**CITY OF WILSONVILLE
SECOND AMENDMENT TO CONSTRUCTION CONTRACT****5th Street/Kinsman Road Extension**

Exhibit A - Change Order #02
Pay Item Adjustment

Exhibit B – Change Order #02

Railroad Utility Crossing Casing Design Modifications

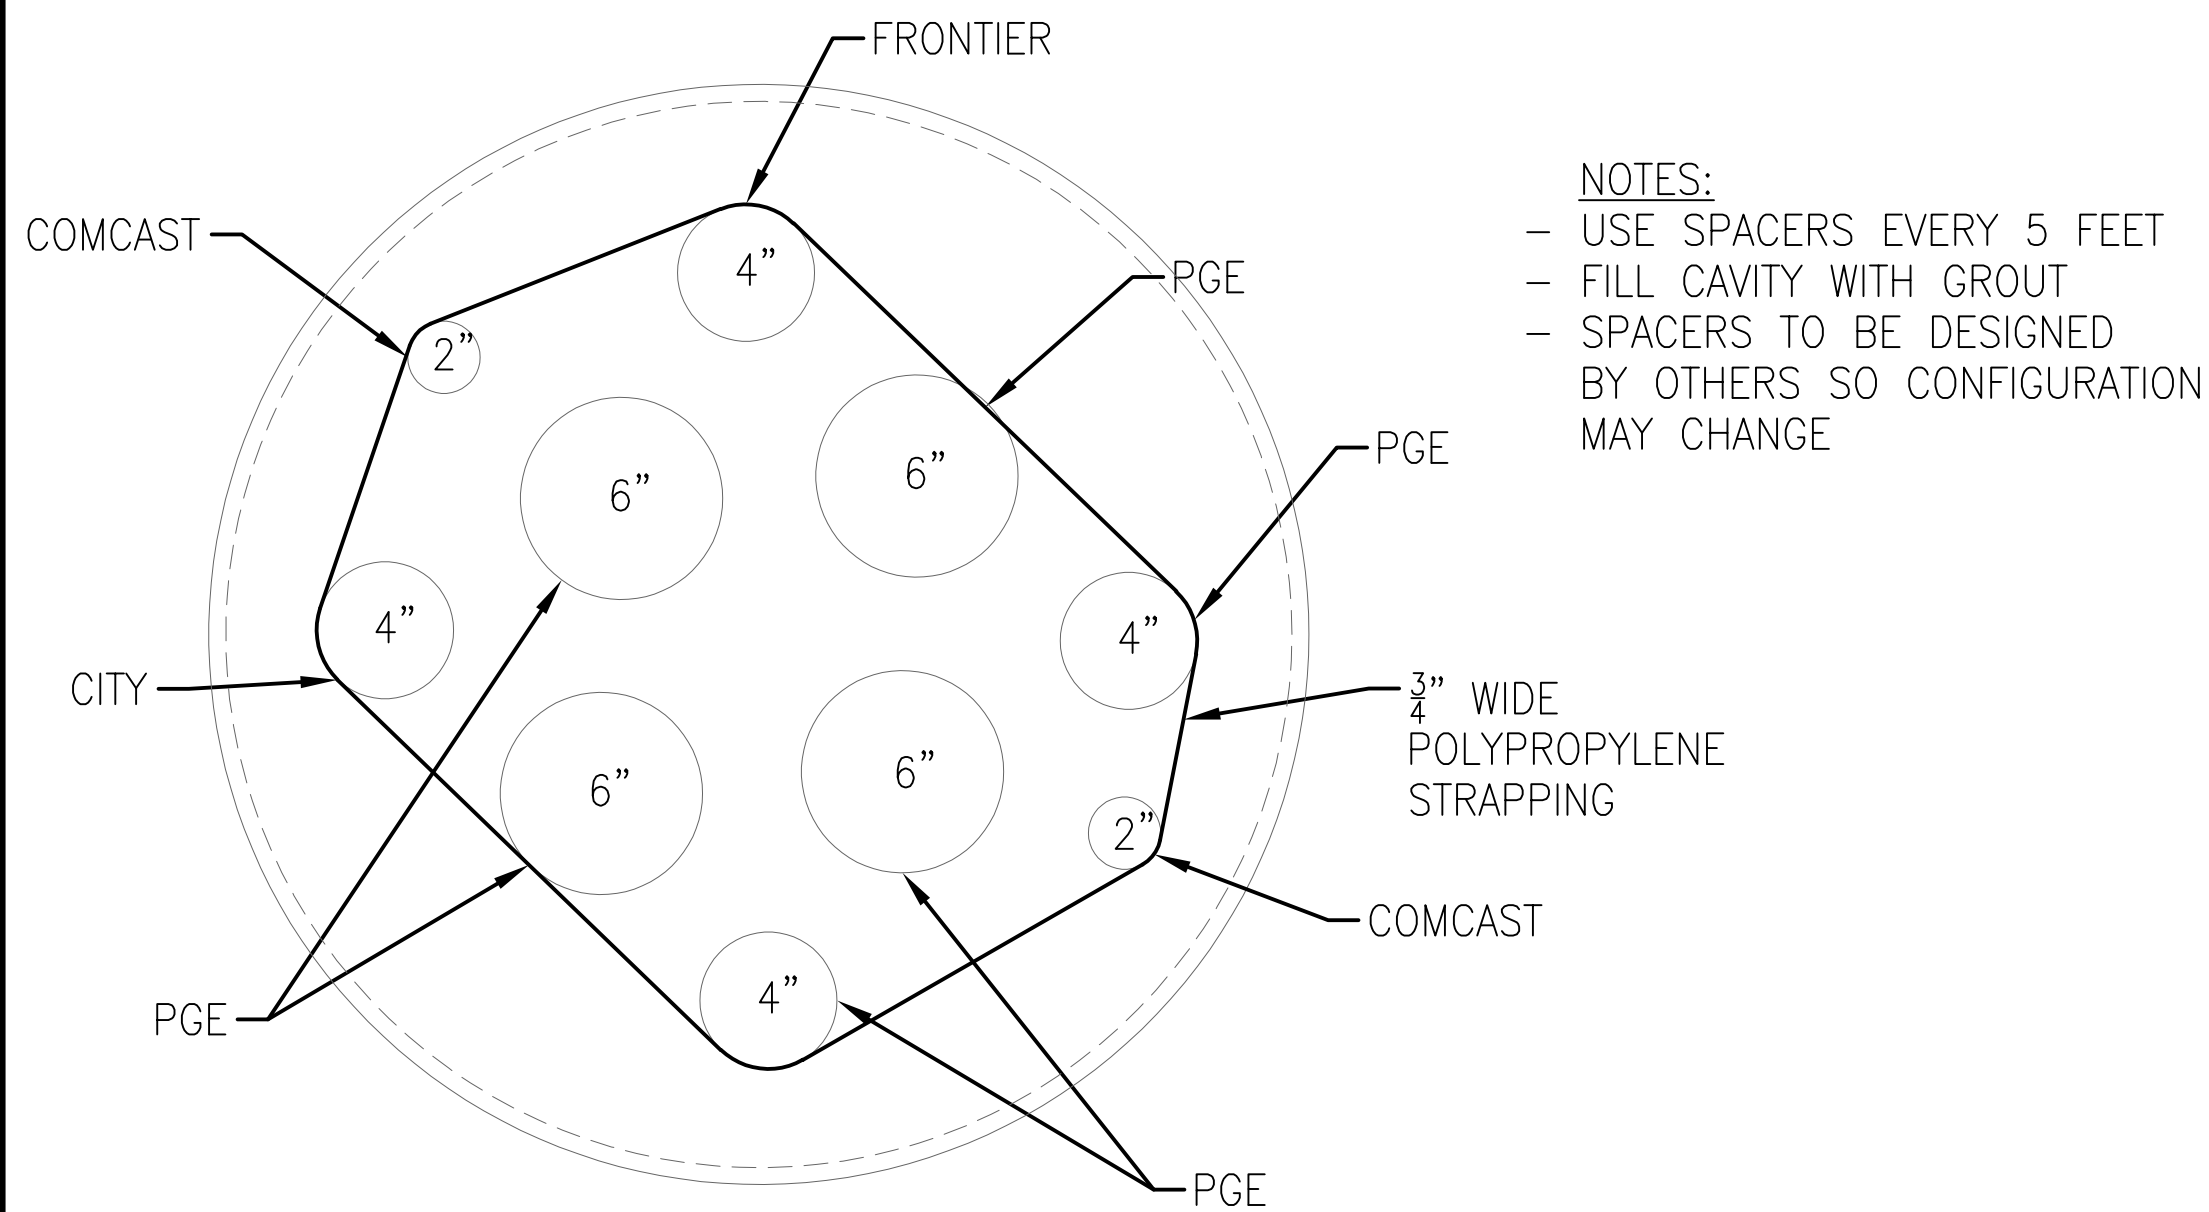
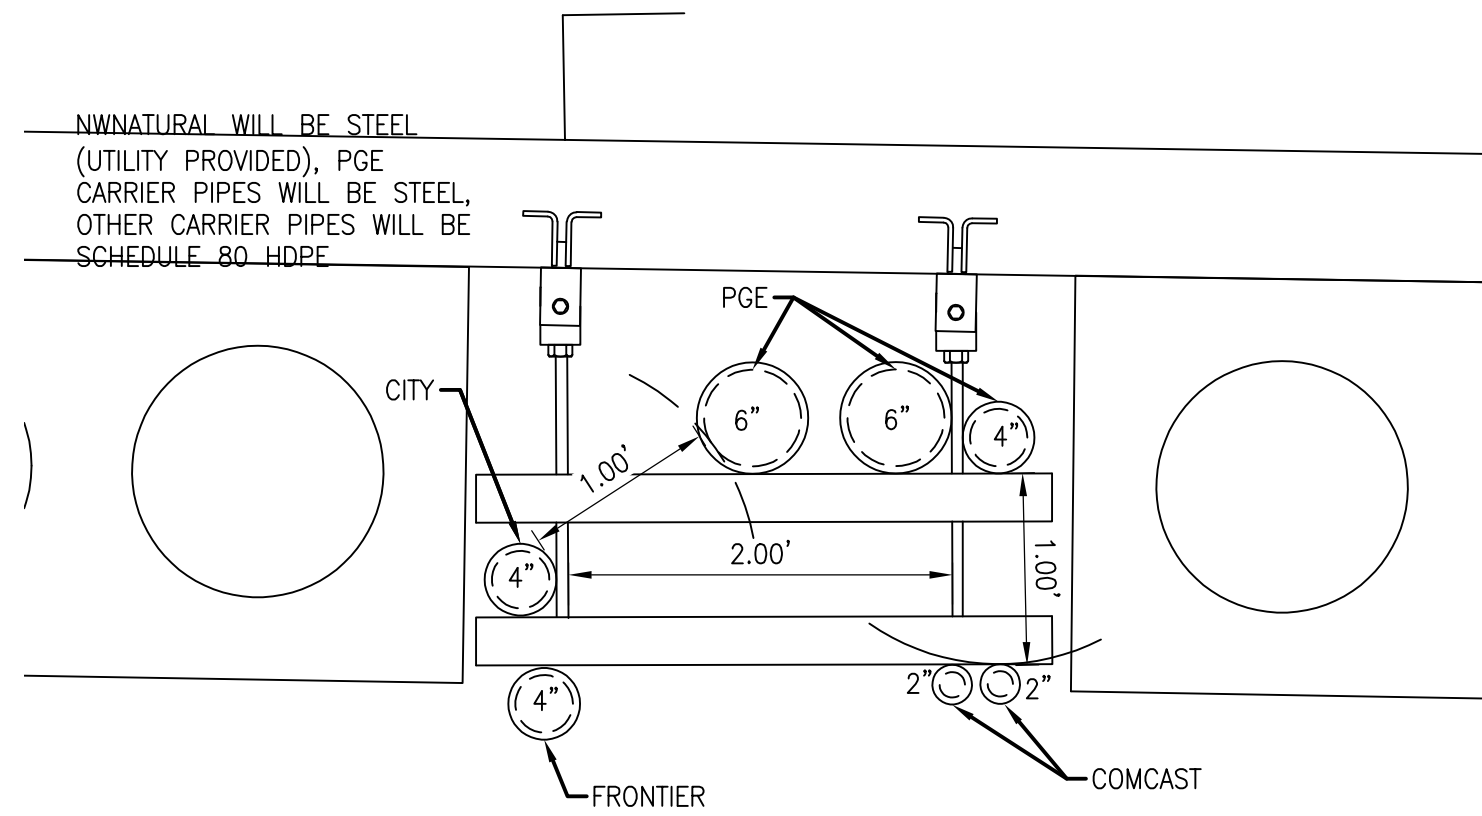
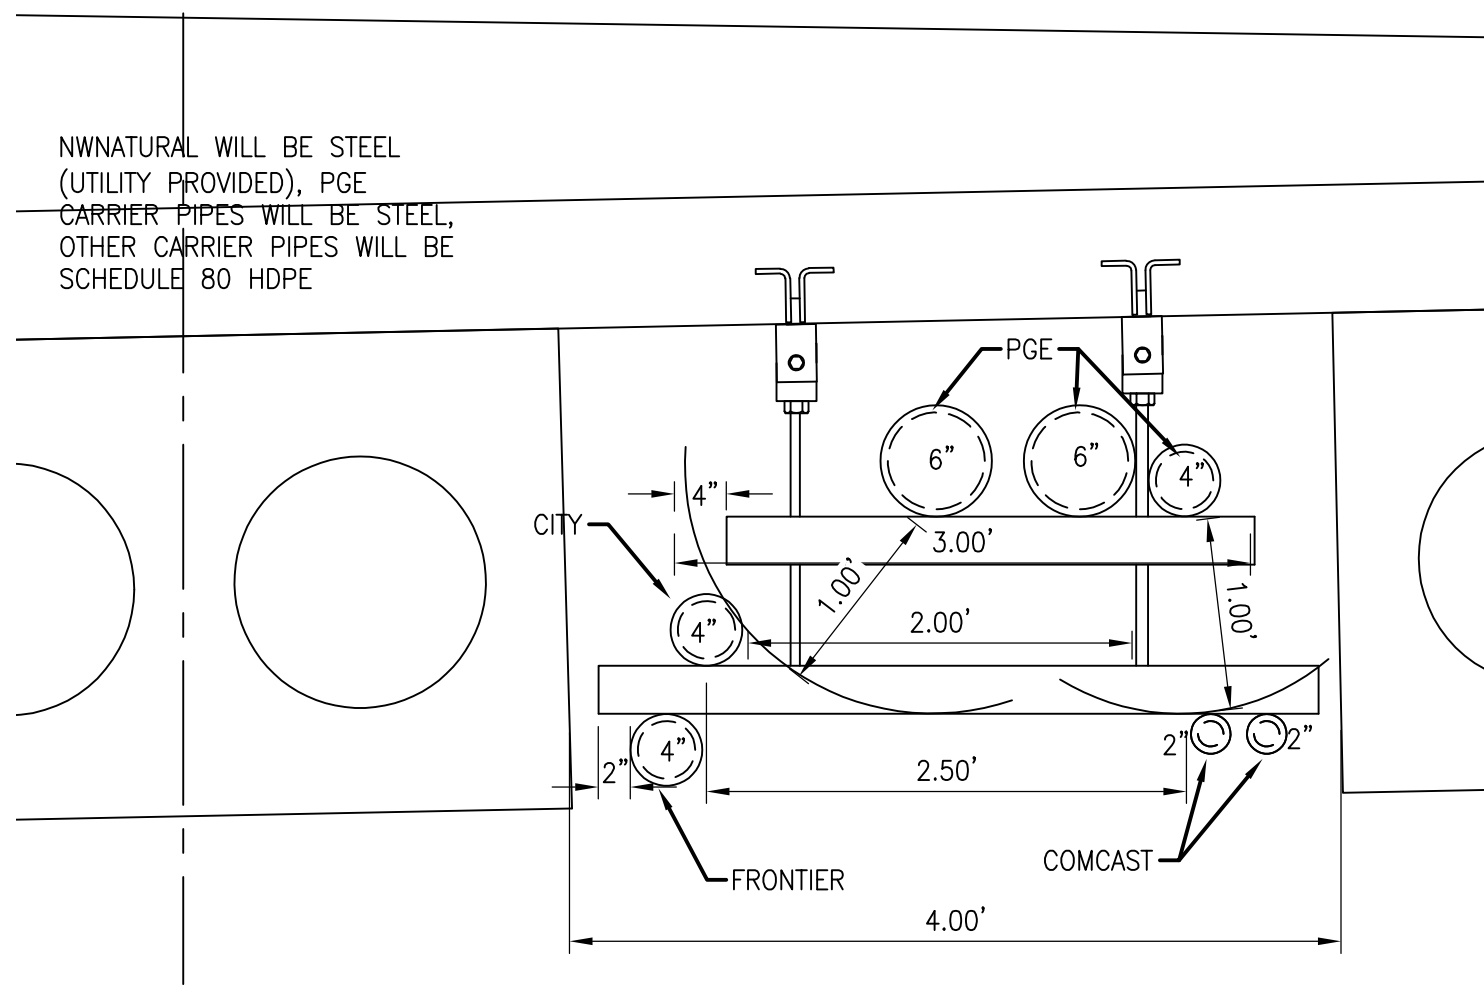
During bore installation of the 6” diameter casing pipe for the natural gas pipeline crossing beneath the railroad tracks, the Contractor was unable to complete the work after a number of attempts due to the presence of boulders. The Contractor determined that the small size of the casing pipe does not provide enough room to access and remove the conflicting portions of boulders. The Contractor proposes an upsized 36” diameter casing pipe to provide the needed space to remove conflicting boulders and complete installation of the needed casing pipe. In addition, the Contractor mistakenly installed a larger, 36” casing for the City water pipeline, rather than the 18” casing called for in the construction documents. The utility casing pipe design changes for the railroad crossing are included on pages 23-24 of Exhibit C.

Item	Description	Qty	Unit	Unit Price	Extension
Description of Change(s)					
Boulders were encountered while installing the 6" gas casing at the design depth of 7' ; This was not called out in the plans or geotech report and is a differing site condition; this COR reflects the standby time as a result, and the costs to upsize the casing to alleviate the boulder issue.					
Pricing					
Reject	Standby time	1.00	LS	\$ 17,118.04	\$ 17,118.04
Reject	Additional Work Upsize 6" Gas Casing to 36"	1.00	LS	\$ 17,824.20	\$ 17,824.20
Approve	CREDIT BI 55 6" Casing 7 FT Depth	1.00	LS	\$ (40,000.00)	\$ (40,000.00)
Approve	BI 57 36" Casing 7 FT Depth	1.00	LS	\$ 80,000.00	\$ 80,000.00
Reject	Bore Sub Additional DeMob and Mob	1.00	LS	\$ 12,800.00	\$ 12,800.00
Approve	City Share Gas Casing Relocation Work				\$20,000.00
	TOTAL				\$ 60,000.00
Terms, Conditions, and Scope Limits/Clarifications					
Additional contract days will be requested starting from the beginning of the delay on 10/18/2021 to the end of

Note: The City does not agree that the obstructions encountered constitute a differing site condition, but agrees to pay a portion of added work to install a larger casing for the gas line.

1. RR Crossing unforeseen change request. The City will accept the last settlement offer of paying the difference between the 6" casing and the 36" casing for the Gas casing (\$40,000) as well as paying 0.5 of the 6" bid item for all other extra work claimed (\$20,000).
2. Water Quality Curb reinforcing credit. The City will accept the last credit amount of \$7,000.00.
